ADMINISTRATIVE DESIGN REVIEW
 RECOMMENDATION PACKET
 2301 E DENNY WAY
 #3022300

SITE ADDRESS	2301 E DENNY WAY
PARCEL NUMBERS	140730-0055 140730-0045
SDCI #S	3022300, 6494941
APPLICANT	Neiman Taber Architects 1421 34th Avenue, Suite 100 Seattle, WA 98122 (206) 760-5550
CONTACT	David Neiman dn@neimantaber.com
ZONING	LR3
LOT SIZE	8,006 SF
ALLOWABLE FAR	2.0 (16,012 SF)
PROPOSED UNITS	46 UNITS: (44) SEDUs, (2) 1 BEDRM
FREQUENT TRANSIT	Yes
PROPOSED HEIGHT	44’

SHORT TERM BIKE PARKING LOCATED AT SOUTH ENTRY RAMP

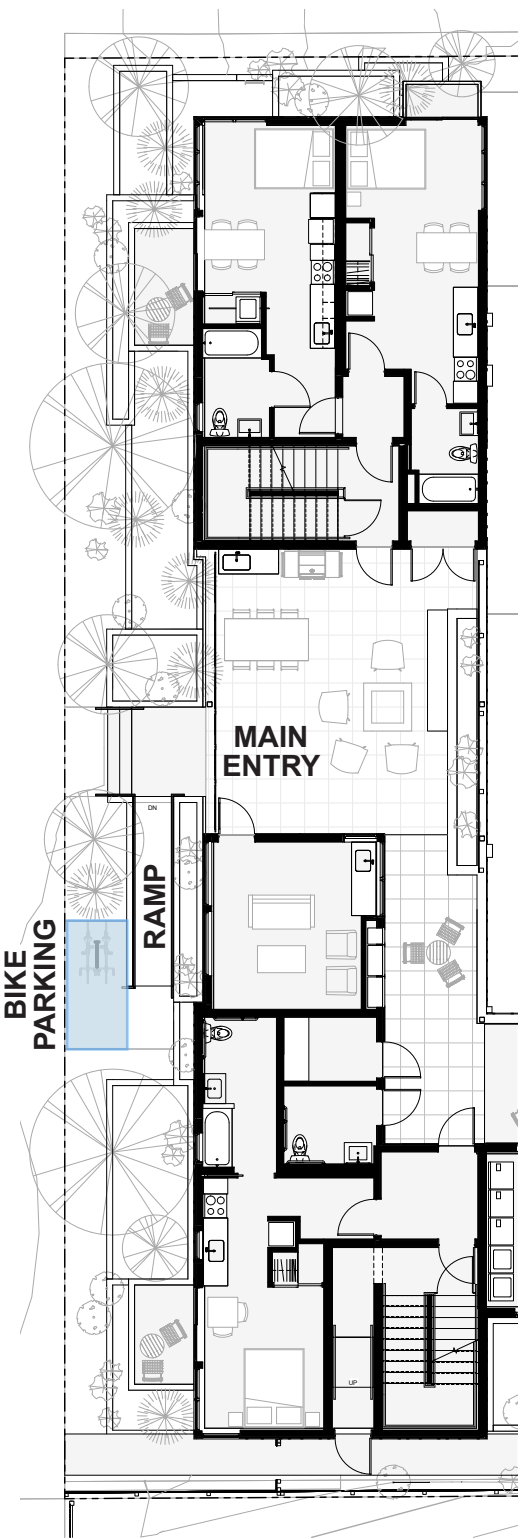
Locations for both short term bicycle parking and long term bicycle storage have now been provided. For the recommendation phase of the project staff would like to see additional details pertaining to the actual location and potential bike rack designs for the short term bike parking as discussed on page 39 of the revised EDG packet. (PL4-B-2).

RESPONSE: Bike parking is located directly adjacent to the accessibility ramp at the main entrance. See rendering and floor plan, right. This allows residents to utilize the ramp with their bike, if needed. A simple and sturdy bike parking stand (A), similar to the model below and in the rendering, will accent the contemporary design and hold up over time.

A. SECTION AT HIGH WINDOW

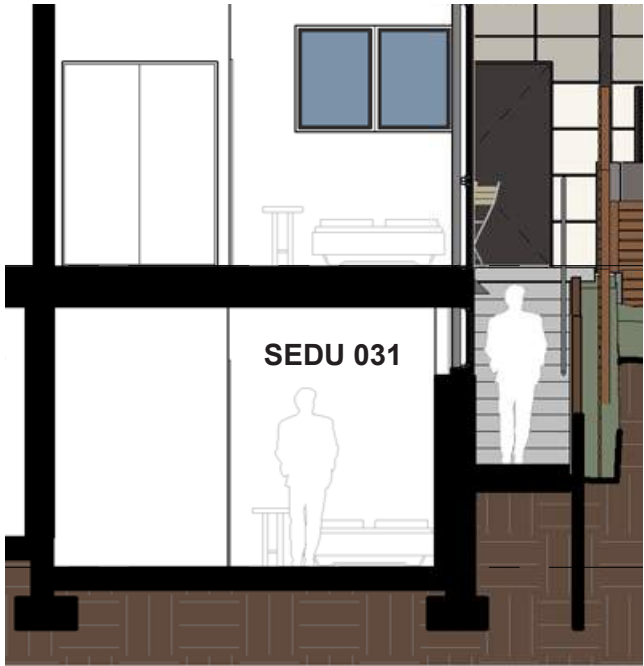
Staff appreciates the further development of the basement floor plan which depicts the location of the window wells and the potential for gaining daylight into the basement living units. Staff would like to see additional details depicting the placement of windows in the basement SEDU unit located at the northeast corner of the laundry facilities as the unit is immediately adjacent to the descending stairs leading from the lounge area to the basement units to the east. Staff is concerned with the potential privacy impacts into the unit. The added details can be made a part of the Recommendation packet. (CS1-B-2; DC3-B).

Sections A and B are provided, left, to depict the relationship between the walkway, the windows and the unit. The unit is challenged by privacy issues, however, we do not want to limit the choice for residents to access views out by changing the glass from vision glass to frosted. Therefore, the design will utilize both bottom-up-top-down blinds, as well as sheer curtains to give residents choices between layers of privacy and views.

EAST ELEVATION PRIVACY STUDY

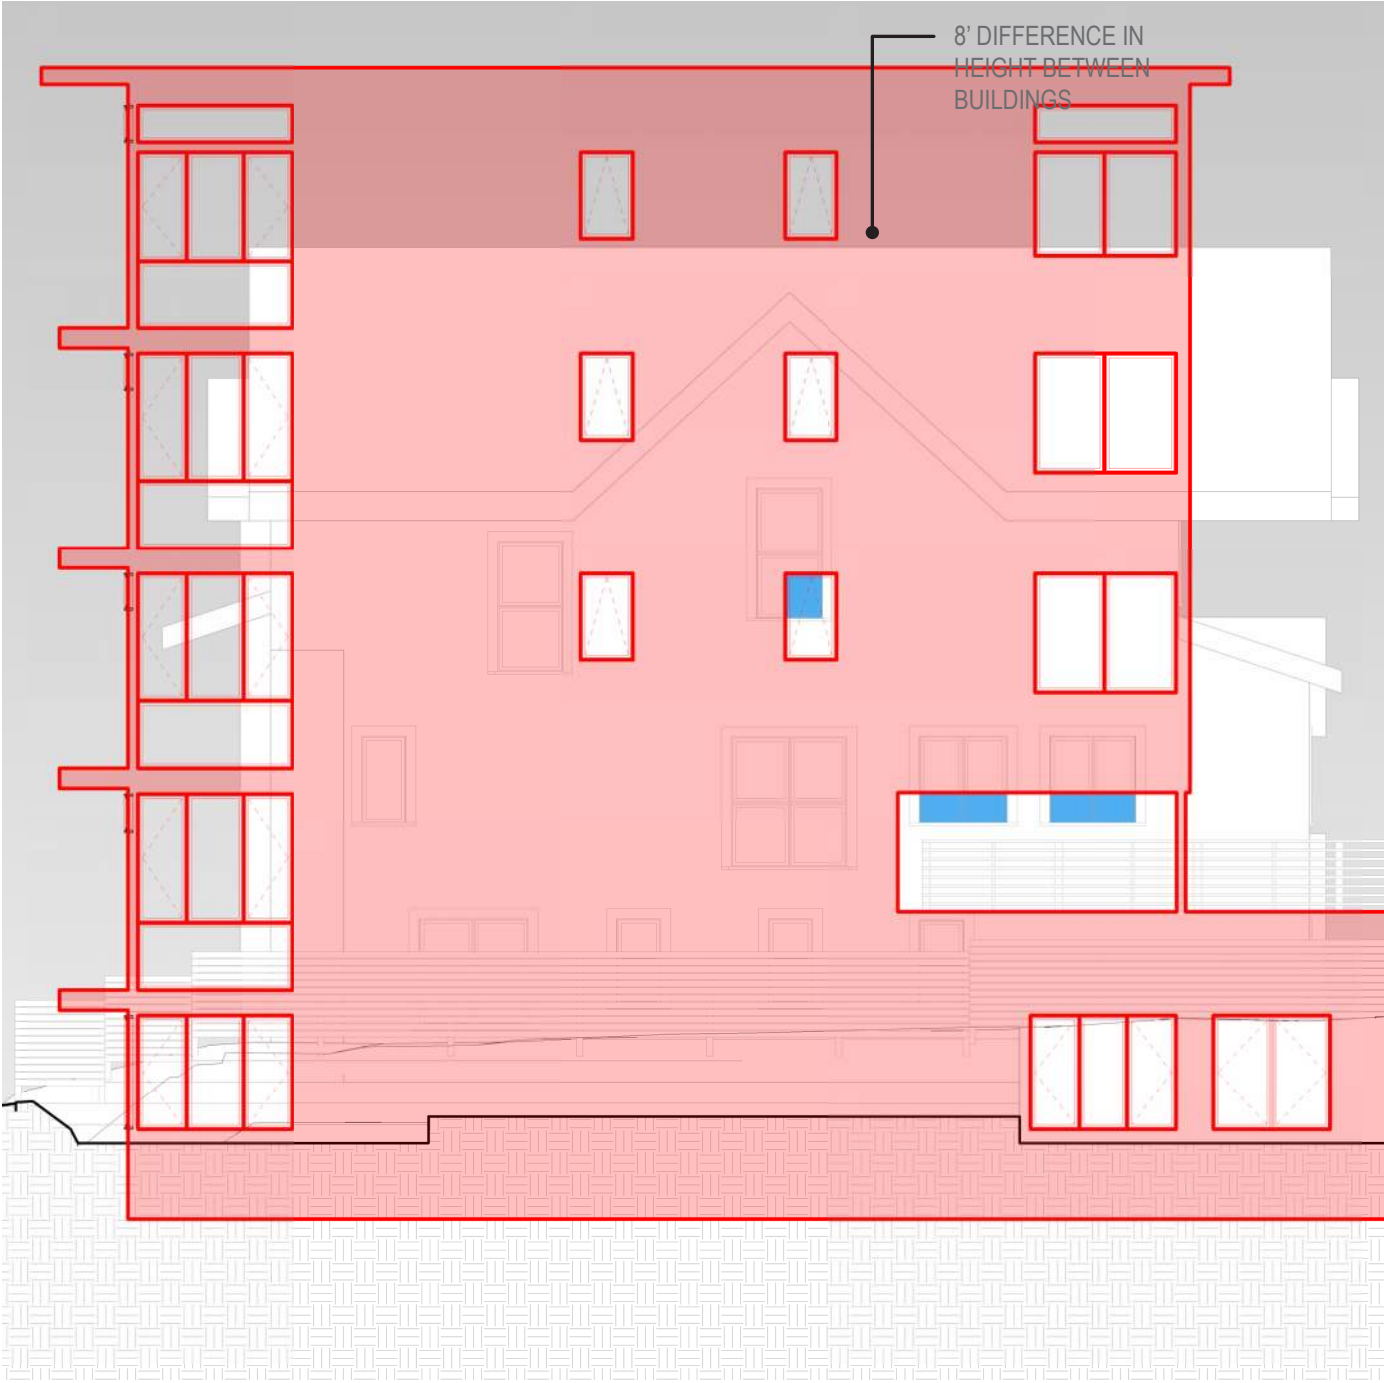
While privacy studies have been provided on pages 60 and 61 of the revised packet, Staff would like to get a better understanding of the privacy study in relationship to the proposed landscaping and fencing similar to what is being depicted in image “D” on page 54 of the packet. This added information can be made a part of the Recommendation packet submission. (CS2-C, CS2-D-1, CS2-D-5, PL3-B, DC2-C).

RESPONSE: The project uses a number of strategies to maintain respectful privacy relationships with the neighboring properties. Windows are offset in elevation. Floors are also offset from neighbors’ floors in order to jog window alignment at eye level. Privacy fences will provide screening for ground level neighbors’ windows from both project exterior amenities, as well as windows.

The privacy studies at the north elevation for the south building and east elevation for the north building, on page 45, indicate the minimal privacy conflicts between the project and the adjacent single family homes. The section, right, depicts the fence and vines, such as clematis and silvervein creeper, which will mitigate the privacy conflicts at the lower levels.

PRIVACY FENCE ALONG SOUTH PROPERTY LINE

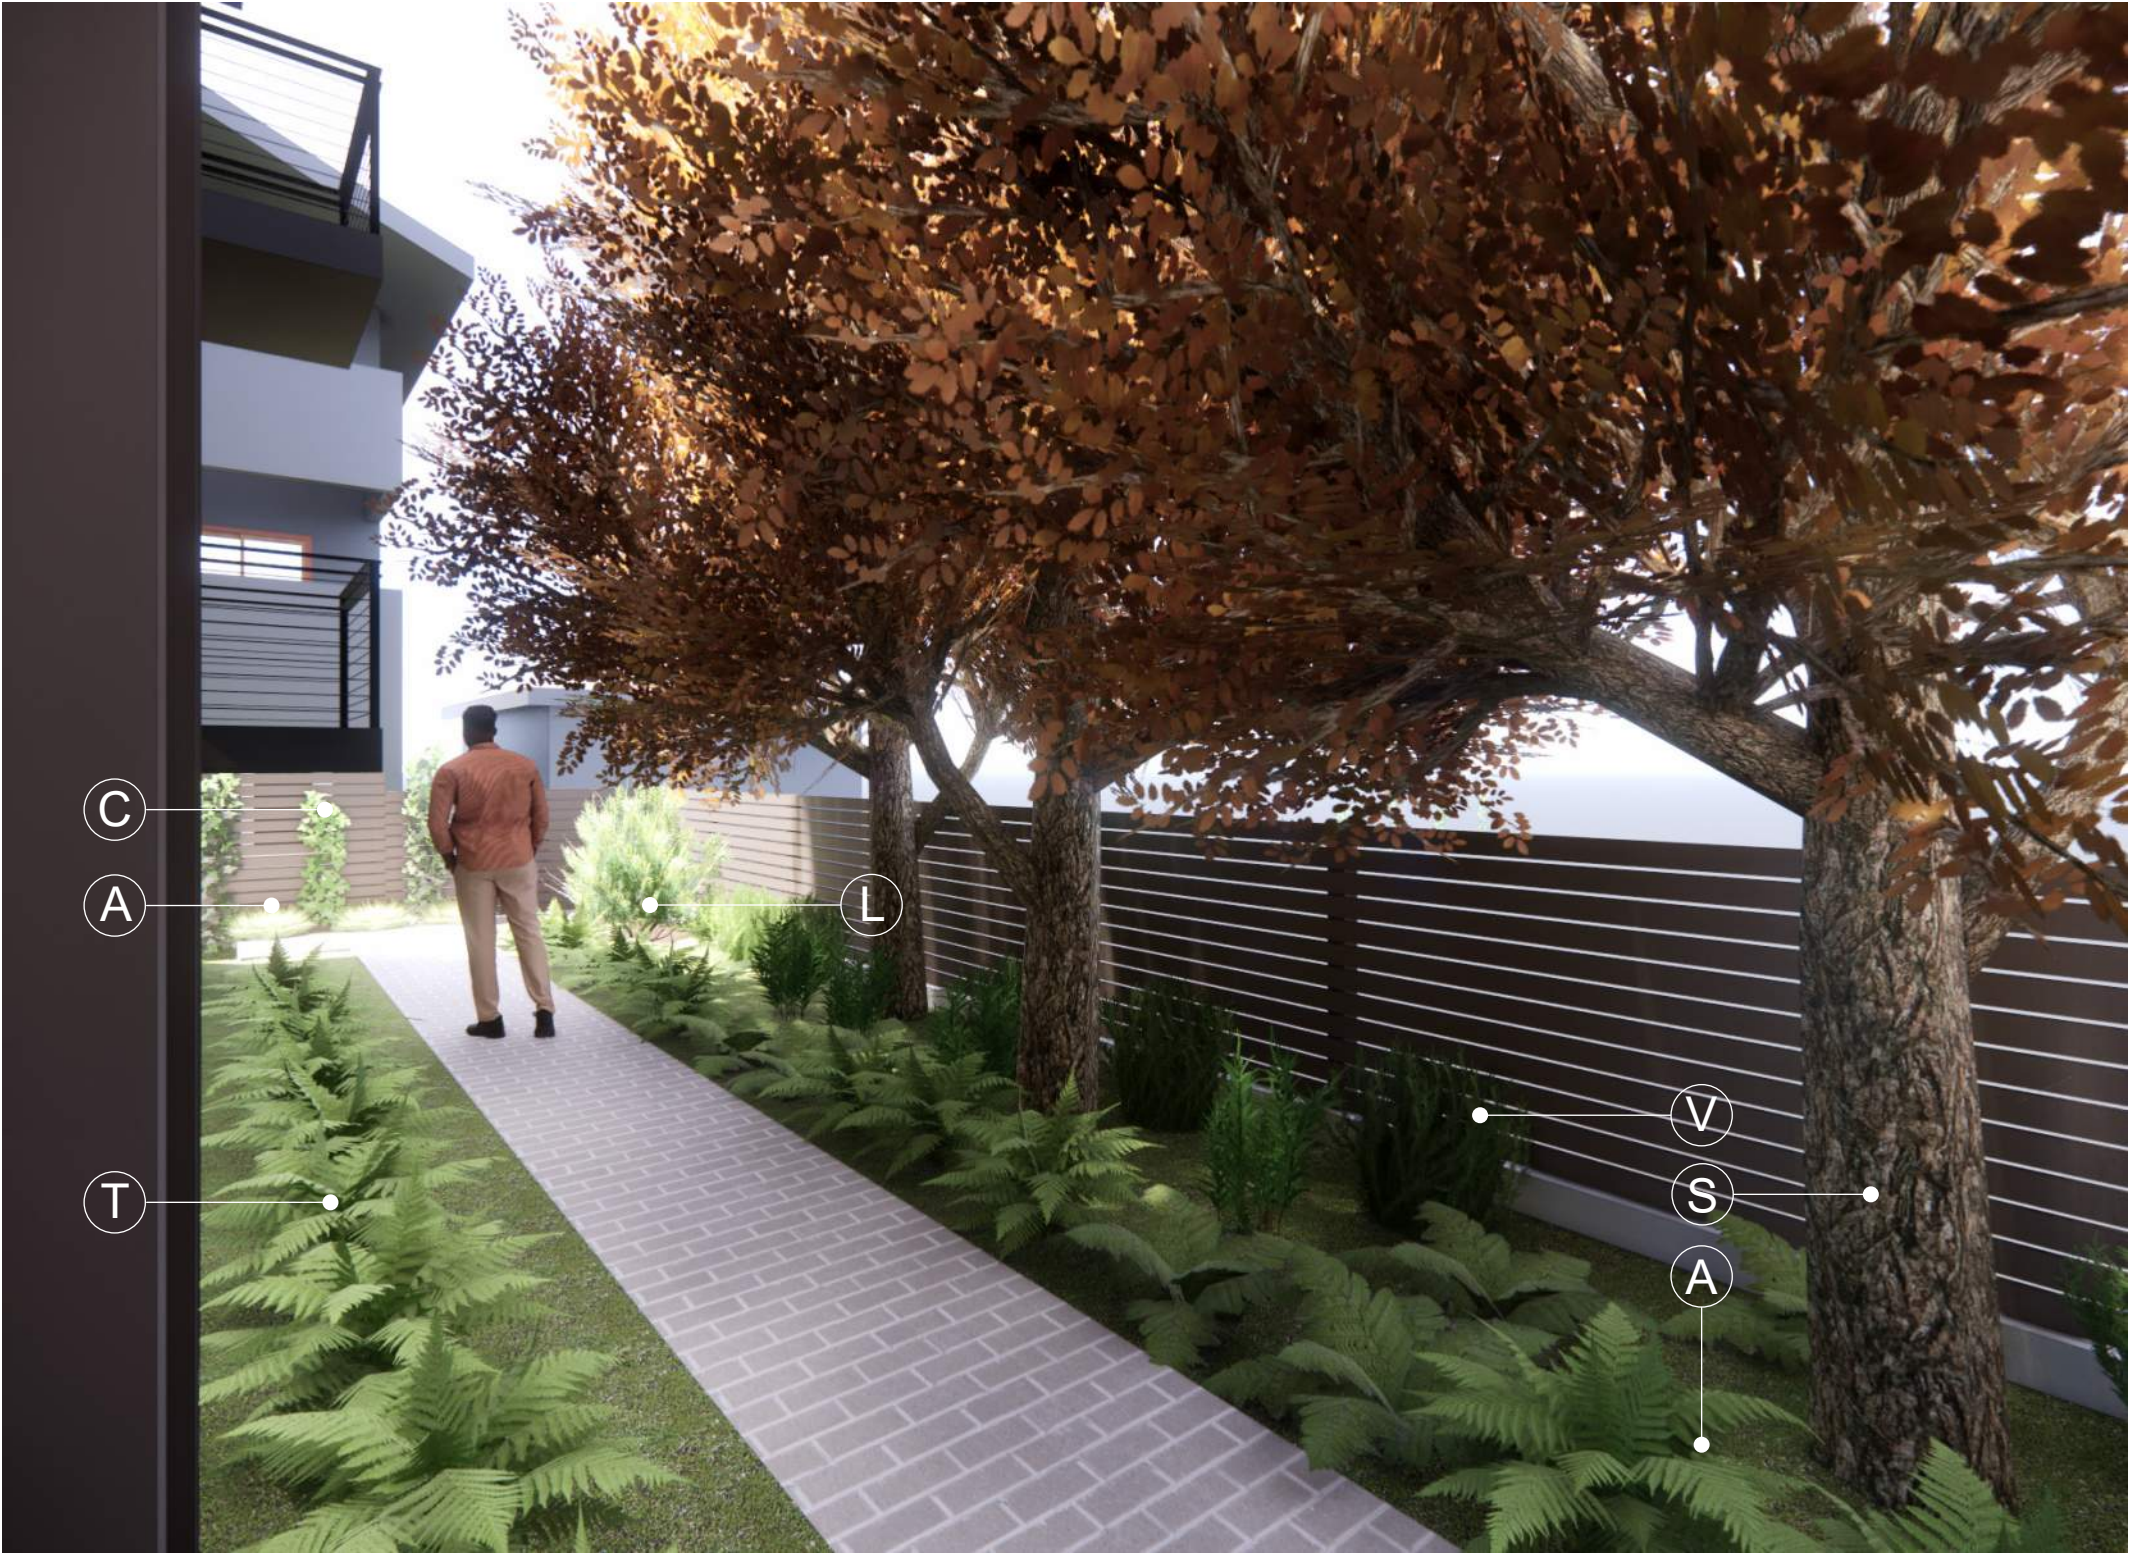
Staff requested more information regarding the landscaping buffer along the southern property line for purposes of screening from the adjacent residential property located to the south.

The revised packet indicates that native landscaping will be used in the building notch that faces to the south as well as added landscaping to the southeast, towards the alley, and to the southwest, along 23rd. There will also be privacy fencing and planting strip along the perimeter with neighboring properties on all sides. For the Recommendation phase, Staff would like to see a more robust depiction of the native planting in the form of a landscape planting plan that depicts the screening of adjacent properties along with the type and dimensions of the fencing. (CS2-D-5, PL3-B, DC4-D) .

RESPONSE: Renderings, right, depict the character of the fence and plantings and also key to the landscape plan on page 48 and planting species images on page 49.

ROOF DETAIL

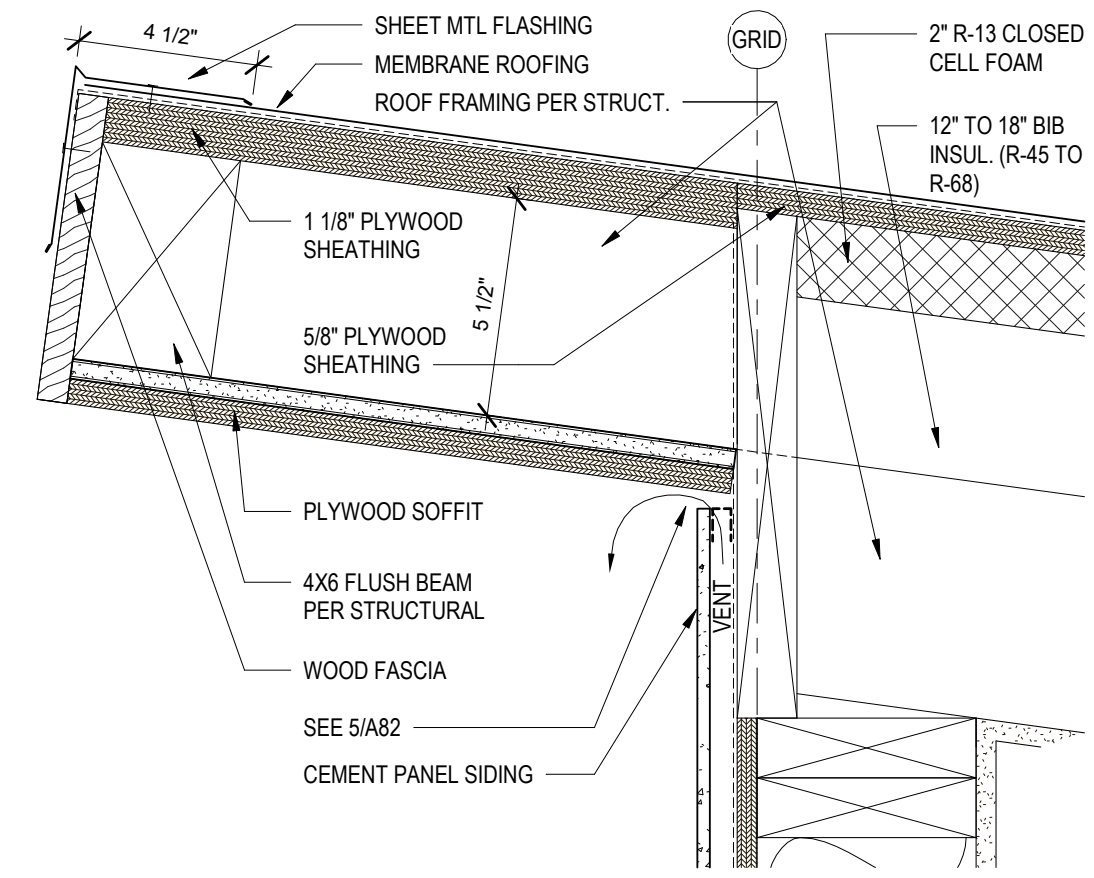
Staff questions the use of the roof form depicted in the renderings in the revised EDG packet. The form appears to be unnecessarily thick and heavy. Revise the roof form to be thinner and lighter with less structure cantilevering over the exterior wall should be explored. The roof form may use exposed beams or other design element to achieve this.

RESPONSE: The design has been revised and the roof line will be lighter and thinner, with 2x6 rafter tails sistered onto the roof structure. See revised rendering and roof detail below.
